**CULTURAL RESOURCES OFFICE
PRESERVATION BOARD
REGULAR MEETING
MONDAY JANUARY 27, 2014 — 4:00 P.M.
1520 MARKET ST. #2000
www.stlouis-mo.gov/cultural-resources**

DATE: January 27, 2014
ADDRESS: 4643 Lindell Boulevard
ITEM: Second Preliminary Review: demolish an office building and construct a 12-story residential building with street-level retail space.
JURISDICTION: Central West End Certified Local Historic District — Ward 28
STAFF: Betsy Bradley, Cultural Resources Office

DATE: January 27, 2014
ADDRESS: 1220 Dolman Street
ITEM: Preliminary Review: New construction, single-family house.
JURISDICTION: Lafayette Square Certified Local Historic District — Ward 6
STAFF: Andrea Gagen, Cultural Resources Office

SITE PLAN

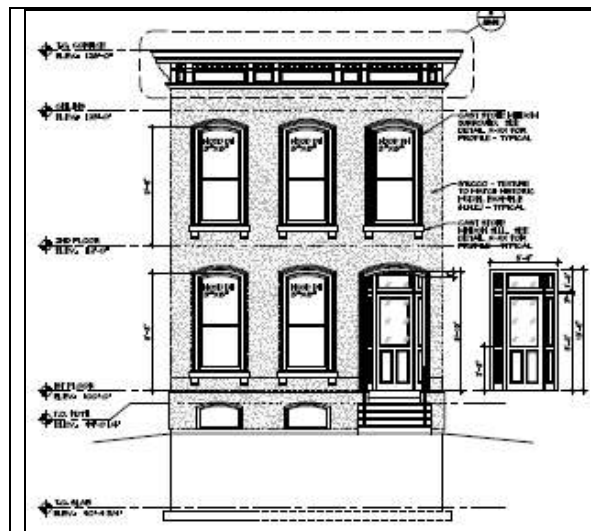
The site plan meets the standards for alignment, but the setback does not seem to be appropriate for Dolman. It is approximately 5 foot less than that on the buildings across the street, a distance recommended to the applicant.

RECOMMENDATION:
That the Preservation Board grant preliminary approval to this proposal if the setback issue is addressed and with the condition that the design be developed as proposed and that design details will be reviewed and approved by the Cultural Resources.

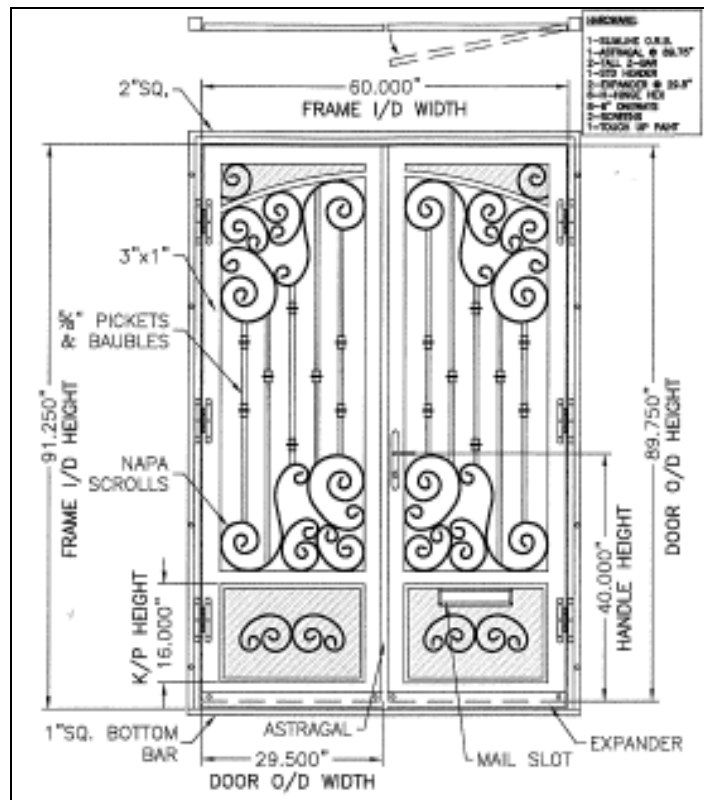
- 3300 Lemp is located in the Benton Park Local Historic District.
- The existing doors at the corner entrance are appropriate for a commercial space in a mixed use building.
- New security bars and doors are not allowed on Public Façades under the historic district standards, unless based on a Model Example is used.
- The proposed security doors are not based on a Model Example, and it is unlikely that such an example could be found, as historic doors most often did not incorporate security bars.
- A mail slot, if needed, could be installed in the bottom panel of one of the existing doors. Security concerns could be addressed through materials installed on the interior of the exiting doors.
